Midway City Council
2 March 2021
Regular Meeting

Farm Meadows Subdivision /
Preliminary and Final Approval

NAME OF PROJECT: Farm Meadows Density Reduction Subdivision

Subject: Farm Meadows Subdivision – Preliminary / Final Approval

FARM MEADOWS

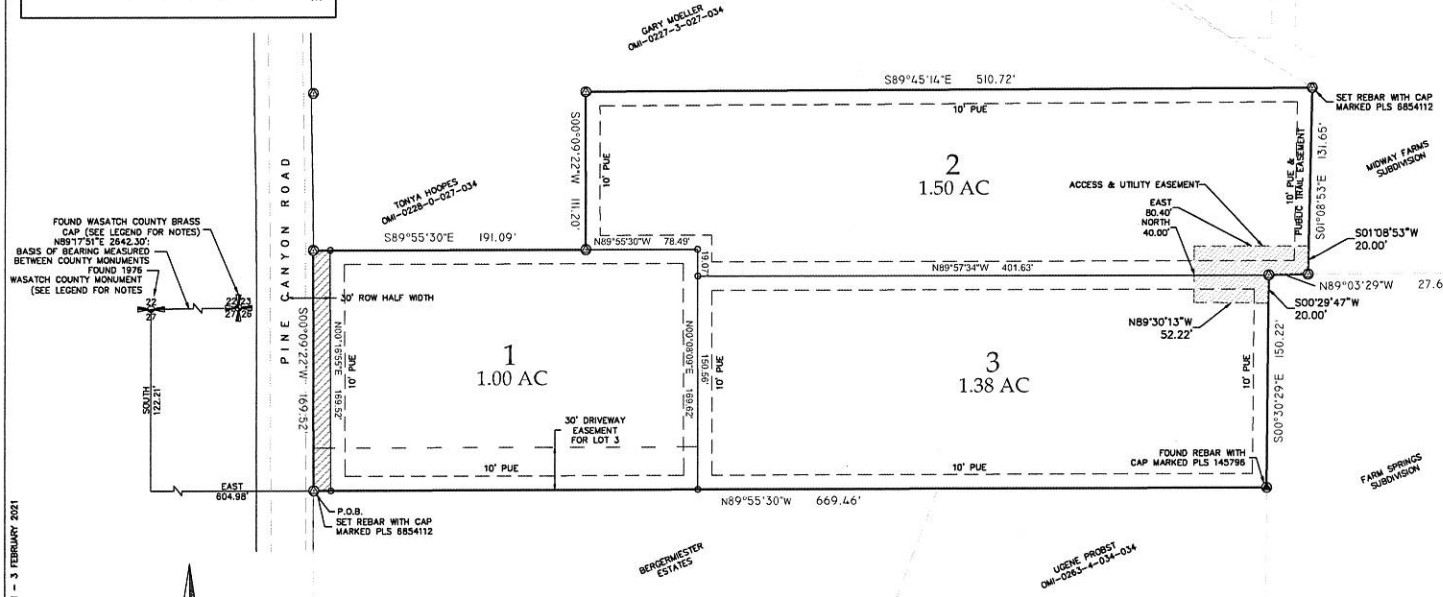
- A 30' driveway easement across lot 1 will need to be placed on the plat map for driveway access to lot 3.
- The right of way half width (28') of the Pine Canyon Road should be dedicated to the city along the frontage of the proposed development.

RYAN DAVIS
FARM MEADOWS
UTILITY
PLAN

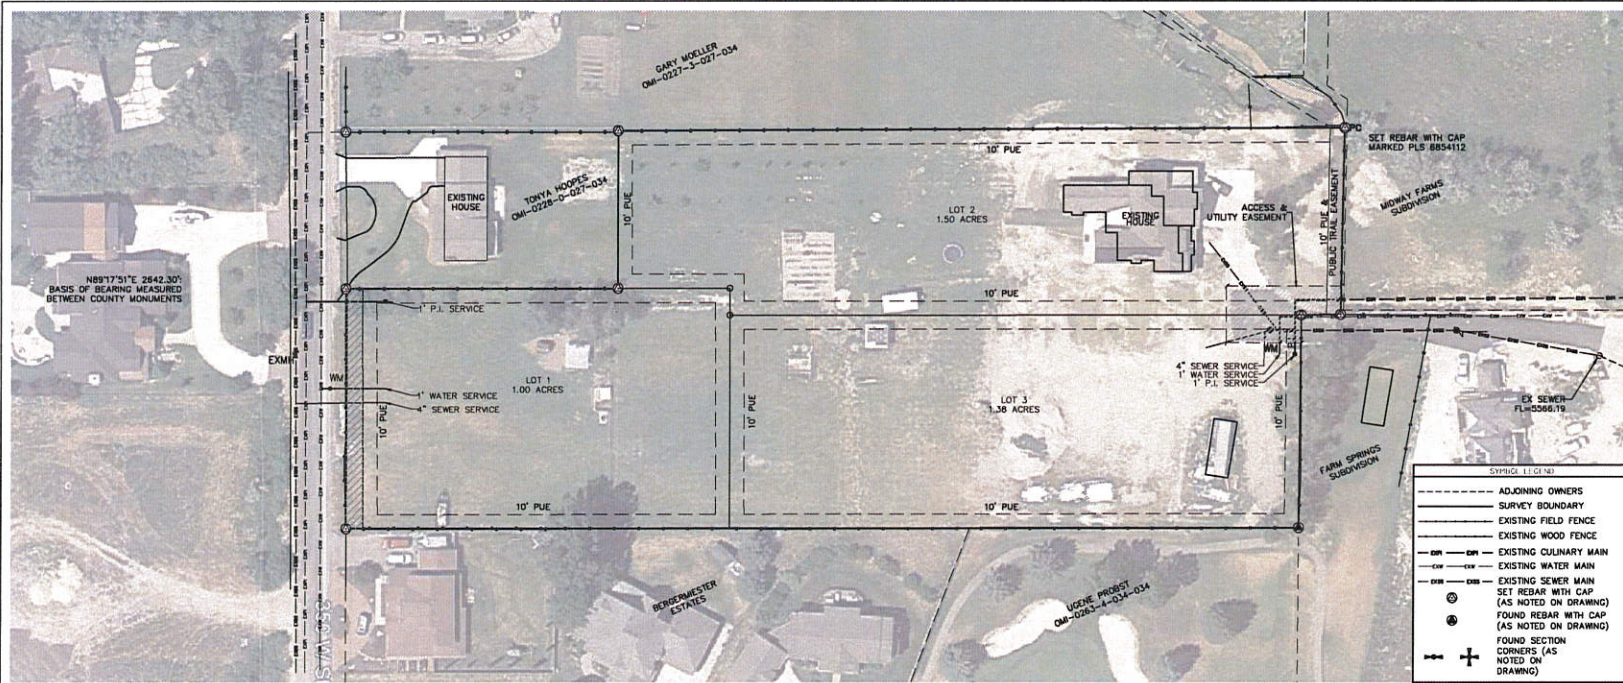
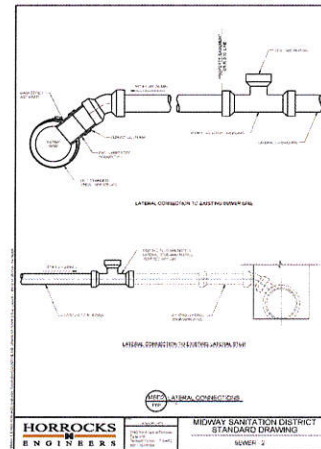
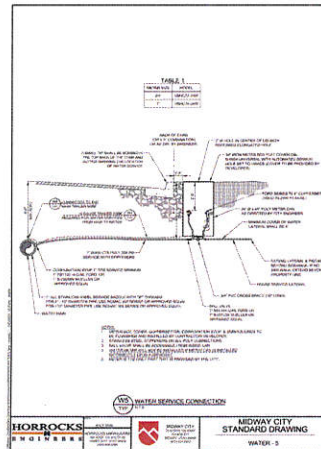
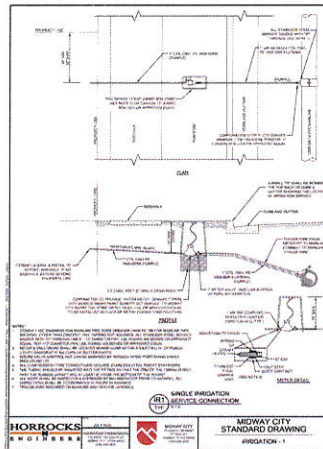
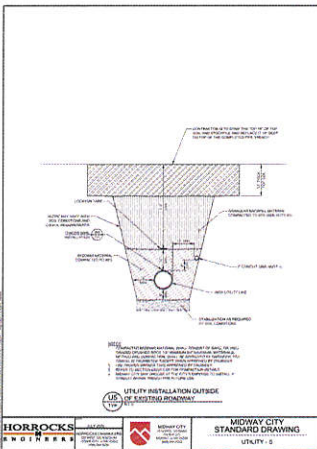
- The proposed development will be served from the Gerber Mahogany Springs pressure zone.
- Lot 1 will connect to the existing water line within Pine Canyon. Lots 2 and 3 will connect to the existing water line within Farm Springs Lane.
- An 8" PVC line will need to be installed from Pine Canyon and tie into the 8" line that was a part of the Farm Springs development. The existing 10" transite line that was abandoned on the Farm Springs development will need to be removed and replaced or abandoned.

- Lot 1 will connect to the existing pressurized line within Pine Canyon and lots 2 and 3 will connect off of Farm Springs Lane.
